[Docket No. NHTSA-2004-18793]

Federal Motor Vehicle Safety Standards; Child Restraint Anchorage Systems

ACTION: Final rule, response to petitions for reconsideration; corrections.

Figure 22. Placement of Symbol on the Seat Back and Seat Cushion of a vehicle

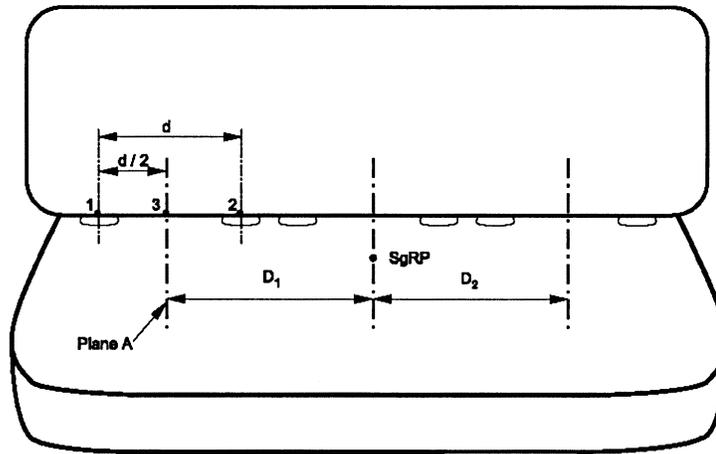
Ford Motor Company petitioned for reconsideration of this decision, stating that the 75 mm upper limit causes problems for vehicles that have large

vertical slits along the bottom of the seat back. The petitioner stated that on these vehicles, to meet the 75 mm upper limit, the access slit would have to be shortened.

Ford stated that increasing the permitted vertical range to 50 to 100 mm would allow longer vertical access slits.

NHTSA's Response: Ford has submitted new information on the need for a longer vertical slit that has convinced NHTSA that the permitted vertical range of the circle should be increased to 100 mm from the LATCH bar. An increase to 100 mm balances the need for a longer slit (to decrease the wear-and-tear on the fabric, leather or other material out of which the seat cover is fabricated) with the need for reasonable proximity of the circle to the anchorage bar. This final rule amends S9.5(a)(3) and Figure 22 to permit the circle to be 50 to 100 mm above the bar.

(3) That is located such that its center is on each seat back between 50 and 100 mm above or on the seat cushion 100 ± 25 mm forward of the intersection of the vertical transverse and horizontal longitudinal planes intersecting at the horizontal centerline of each lower anchorage, as illustrated in Figure 22. The center of the circle must be in the vertical longitudinal plane that passes through the center of the bar (±25 mm).

Figure 20 – Measurement of Distance Between Adjacent Seating Positions for Use in Simultaneous Testing

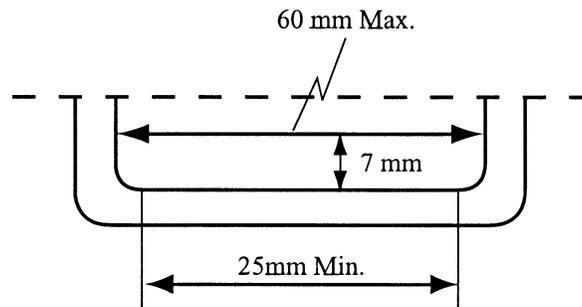
The Alliance raised an issue in a September 13, 2000 submission to a previous docket on FMVSS No. 225 (Docket No. 00-7648-5) that the agency inadvertently did not address. FMVSS No. 225 specifies test conditions and procedures for testing tether anchorages. The standard originally specified that in the case of a row of designated seating positions that has more than one tether anchorage, at the agency's option, each tether anchorage could be tested simultaneously (S6.3.3, 64 FR at 10825). The agency later amended this provision, at the request of the Alliance, to specify that adjacent seating positions should only be subject to simultaneous testing if two child restraints, 400 mm wide, can be properly installed side-by-side (65 FR 46628). (Based on the width of typical child restraints, a center-to-center distance between adjacent seating positions of at least 400 mm is needed to install child restraints in adjacent seating positions properly.) That is, if there is a row of seats in which three adjacent seating positions are equipped with lower anchorages, but it is physically impossible to install three child restraints properly in these seating positions, there is no need to test all three LATCH systems (or tether anchorages) simultaneously. (65 FR at 46637.)

The agency implemented the amendment applying to the simultaneous testing of tether anchorages by amending S6.3.3 and S6.3.4 and adding a Figure 20. In S6.3.3, S6.3.4 and Figure 20, reference is made to measuring a distance between "the two lower anchorages" at the seating position. The Alliance noted that the reference does not provide for determining whether to test simultaneously tether anchorages at seating positions that do not have "lower anchorages" (child restraints would be attached at such seating positions by use of the vehicle's belt system and top tether anchorage). The

Alliance suggested that NHTSA correct S6.3.3, S6.3.4 and Figure 20 by specifying that the midpoint of such seating positions "lies in the vertical longitudinal plane that passes through the SgRP [seating reference point] of the seating position." NHTSA agrees and has made the correction in this document.

(1) The midpoint of the seating position lies in the vertical longitudinal plane that is equidistant from vertical longitudinal planes through the geometric center of each of the two lower anchorages at the seating position. For those seating positions that do not provide lower anchorages, the midpoint of the seating position lies in the vertical longitudinal plane that passes through the SgRP of the seating position.

(1) The midpoint of the seating position lies in the vertical longitudinal plane that is equidistant from vertical longitudinal planes through the geometric center of each of the two lower anchorages at the seating position. For those seating positions that do not provide lower anchorages, the midpoint of the seating position lies in the vertical longitudinal plane that passes through the SgRP of the seating position.

Figure 21. Length of Lower Anchorage Bars

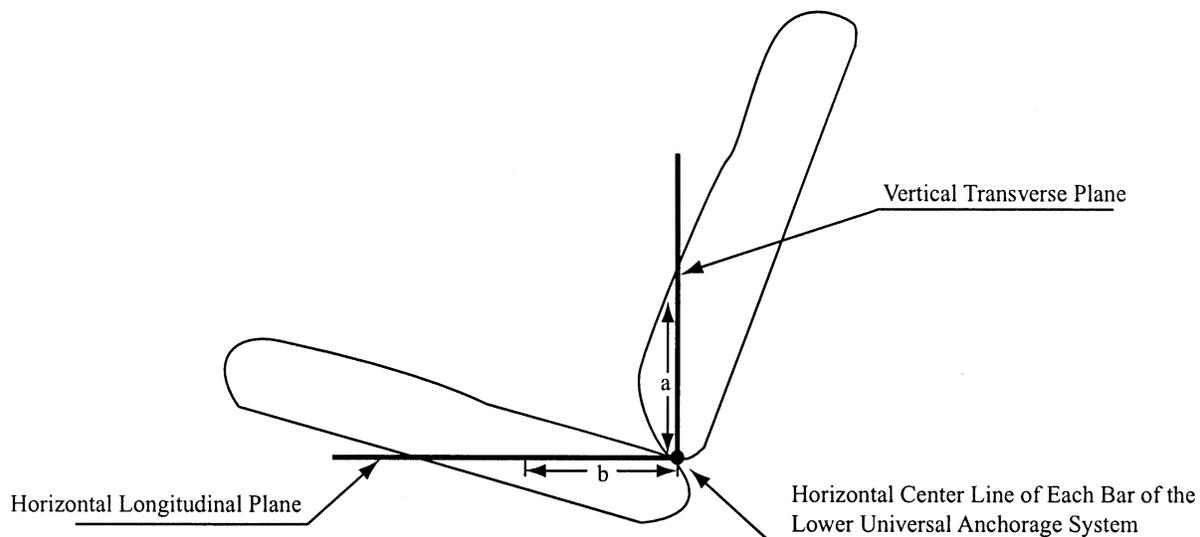
The Alliance and Johnson Controls petitioned for reconsideration of the change made by the June 2003 final rule. The petitioners stated that Figure 21 is incorrect because, they believed, measuring the inside portion of the bar would include the inside radii of the lower anchorage bars in the measurement of bar length. Because curved portions of the bar could be included in what was supposed to be a measurement of the "straight" portion of the bar (the straight portion of the bar to which the child restraint hardware connects), petitioners said that the effect of Figure 21 could limit the straight portion of the bar to less than 50 mm. The Alliance stated that some anchorages that had met S9.1.1(c) with a maximum length of 40 mm may now fail the 50 mm limit when measured according to Figure 21.

In a March 24, 2004 supplement to its petition for reconsideration, the Alliance expressed further concern about Figure 21 because, petitioner stated, it does not show how to measure the length of anchorages that do not have straight and parallel sides. (The bar depicted in the figure had straight and parallel sides.) At the same time, the petitioner recognized that the agency believed that measuring the inside opening of the bar at specified points on the bar improved the objectivity of the test. To address the agency's concern and the alleged problems with Figure 21, the petitioner suggested that S9.1.1(d) be amended to specify: (1) That the bar is measured in a vertical plane 13 mm rearward of the vertical plane that is tangent to the forward face of the anchor bar; and (2) that the bar must not be more than 60 mm in length between the anchor bar supports or other structural members that restrict lateral movement of a child restraint attachment. The petitioner believed that the 13 mm provides enough clearance to enable child restraints to attach to the bar.

NHTSA's Response: The agency has decided that Figure 21 is useful in showing where the LATCH bar is to be measured and should generally be retained. Yet, the agency also agrees that revisions to the figure and to the corresponding regulatory text (S9.1.1(c)) are needed, as discussed by the petitioners. As explained below, this final rule makes the amendments to the figure and regulatory text suggested by the Alliance, with one difference.

allowable bar length to 50 mm, this final rule increases the maximum allowable bar length to 60 mm. Increasing the maximum bar length to 60 mm, measured as shown in Figure 21 (as revised today), will allow for the straight portion of the bar to be increased to 50 mm. This final rule also clarifies that the bar must not be more than 60 mm in length between the anchor bar supports or other structural members of the vehicle that restrict lateral movement of the components of a child restraint that are designed to attach to the bars. In other words, the LATCH anchorage bars are not required to have the "U" shape shown in Figure 21. (The Figure will also bear wording that the depiction of the U shape is for illustration purposes only.)

Another amendment relates to the Alliance's suggestion that S9.1.1(d) be amended to specify that the bar is measured in a vertical plane 13 mm rearward of the vertical plane that is tangent to the forward face of the anchor bar. The agency agrees that defining with more specificity where the bar is measured improves the objectivity of the requirement. However, NHTSA believes that the bar should be measured with reference to the vertical plane that is tangent to the rearward face of the anchor bar (rather than the vertical plane that is tangent to the forward face of the bar), taking into account the 6 mm thickness of the bar. Thus, the bar would be measured in a vertical plane that is 7 mm rearward of the vertical plane that is tangent to the rearward face of the anchor bar.

(c) As shown in Figure 21, are:

- (i) Not less than 25 mm in length, and
- (ii) Are not more than 60 mm in

length between the anchor bar supports or other structural members of the vehicle that restrict lateral movement of the components of a child restraint that are designed to attach to the bars, measured in a vertical plane 7 mm rearward of the vertical plane that is tangent of the rearward face of the anchor bar.
